Monticello Nuclear Generating Plant
Docket No. 50-263
Renewed Facility Operating License No. DPR-22

Subsequent License Renewal Application Supplement 8

SLRA Figure 3.5.2.2.2.6-1

Figure 3.5.2.2.6-1: Section Through Monticello Biological Shield Wall

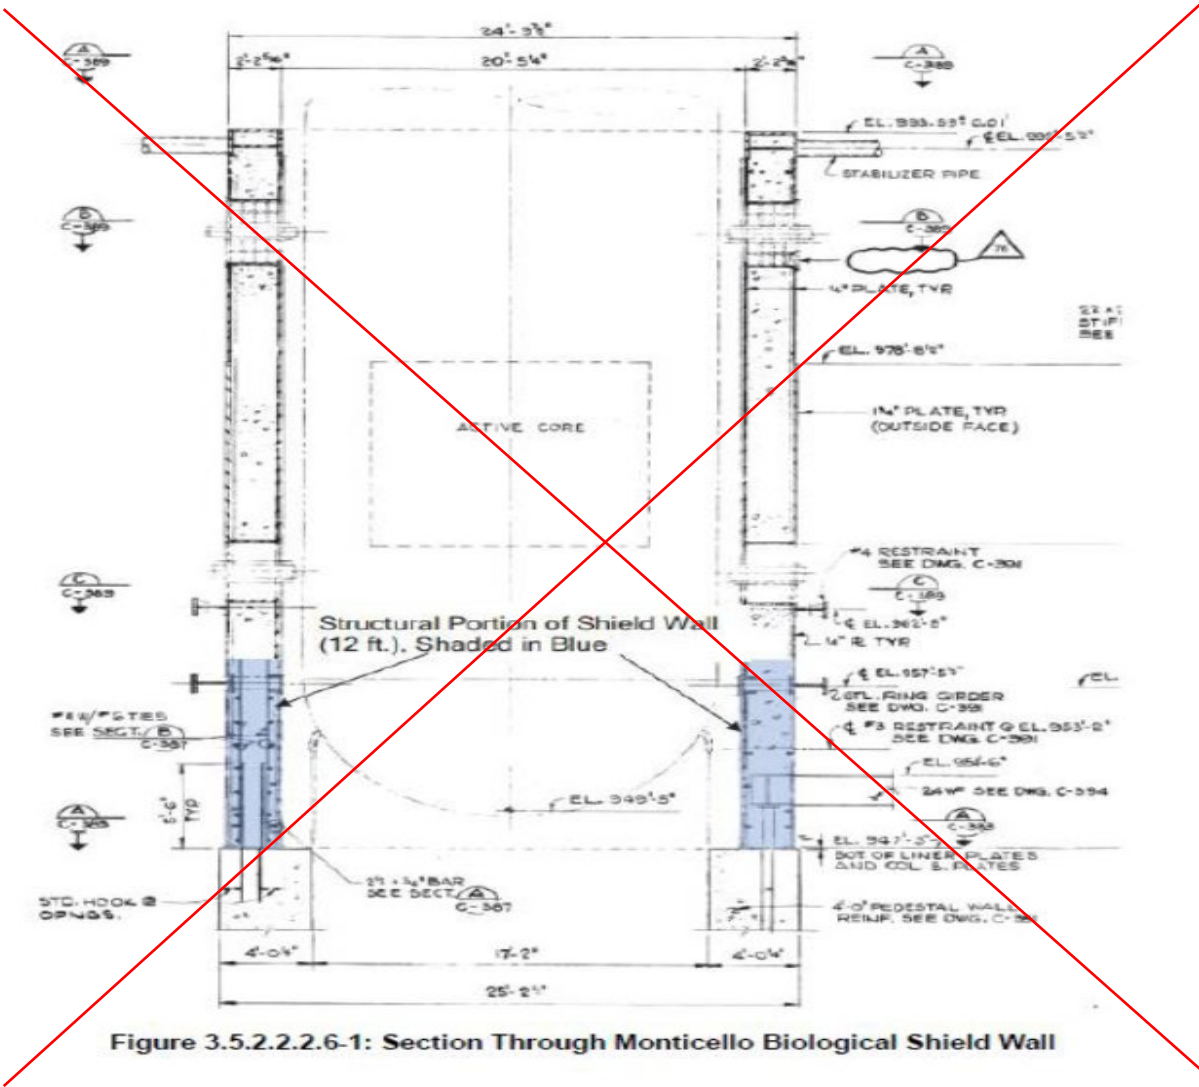
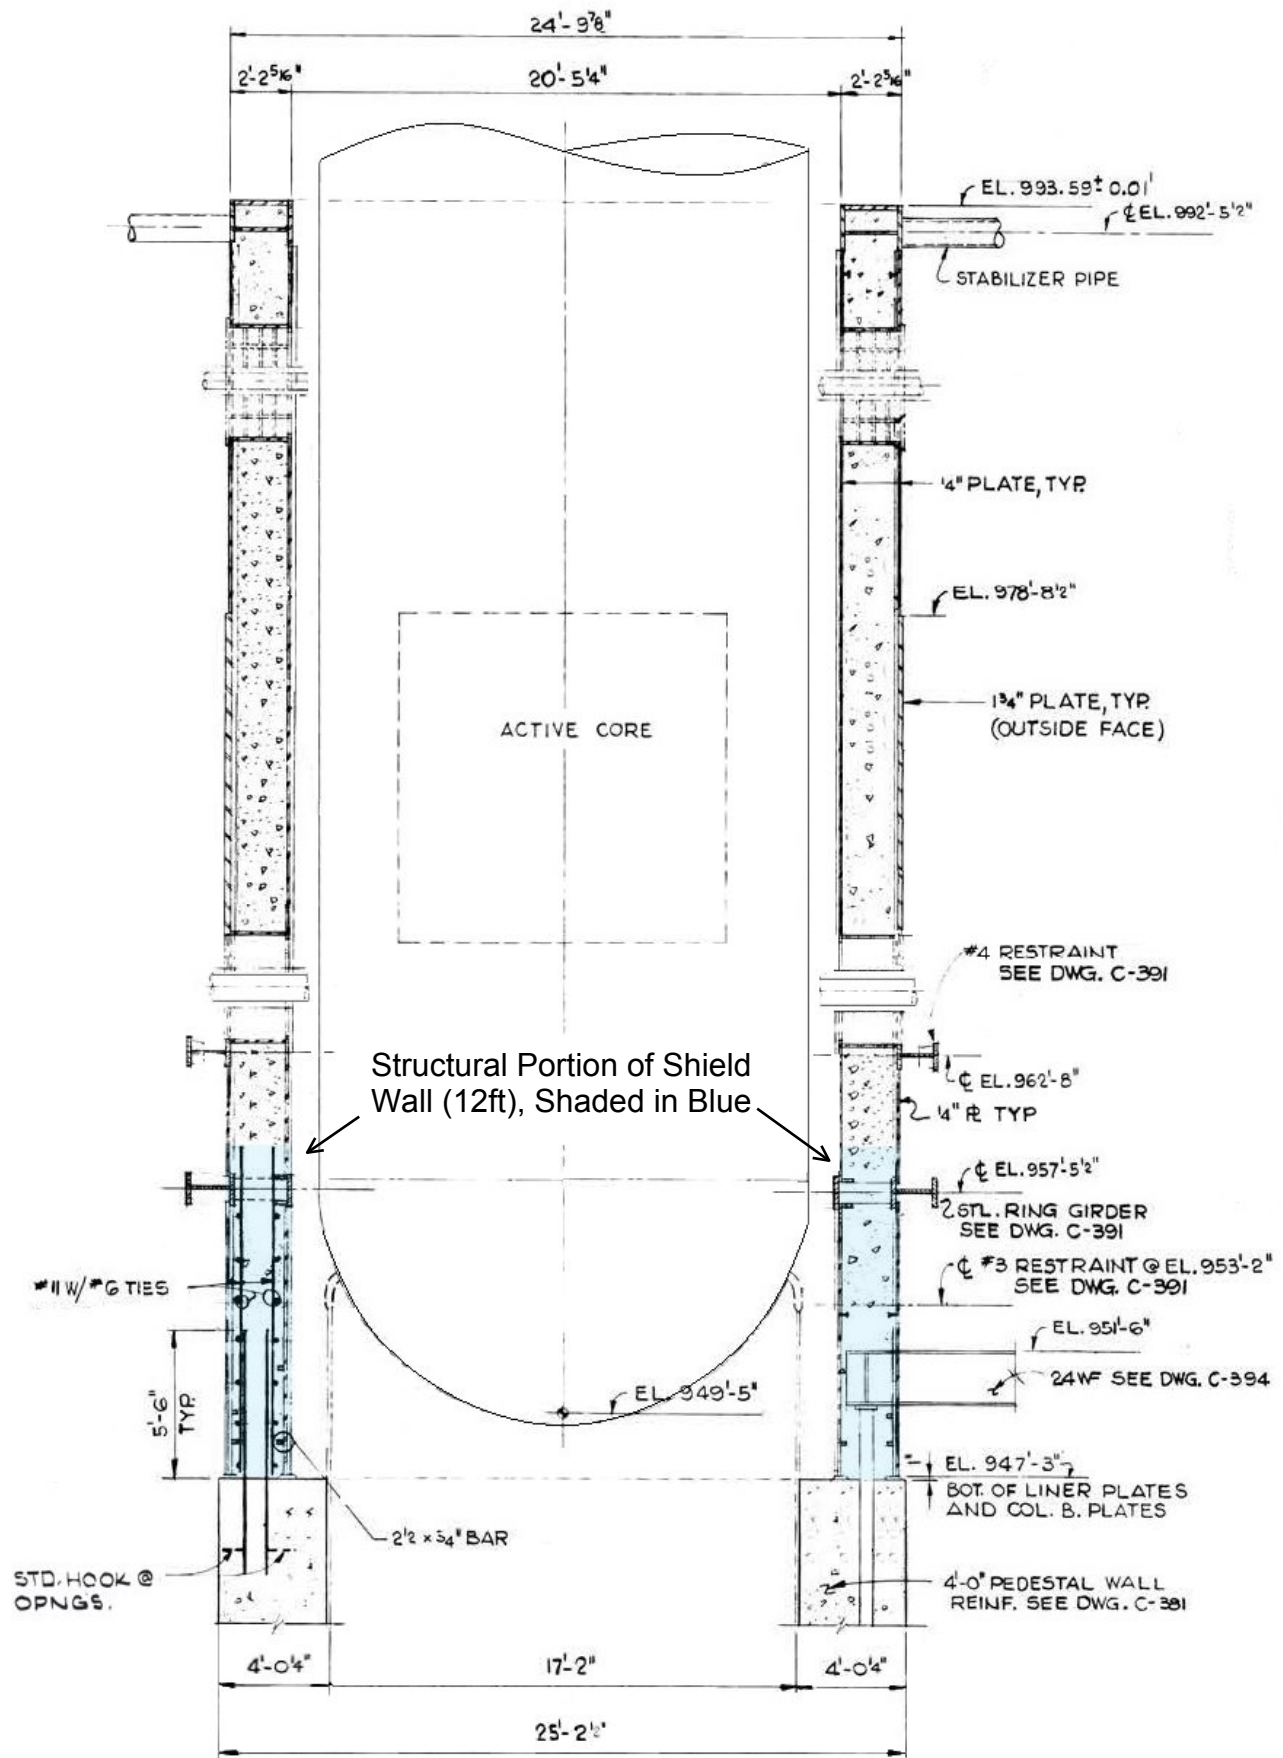
Provided a legible SLRA Figure 3.5.2.2.2.6-1.

SLRA Figure 3.5.2.2.2.6-1 was originally provided in Reference 1, Enclosure 3a. The figure did not reproduce legibly. This change will replace the original SLRA Figure 3.5.2.2.2.6-1 with a more legible figure.

SLRA Figure 3.5.2.2.6-1 on page 3.5-37 is revised as follows:
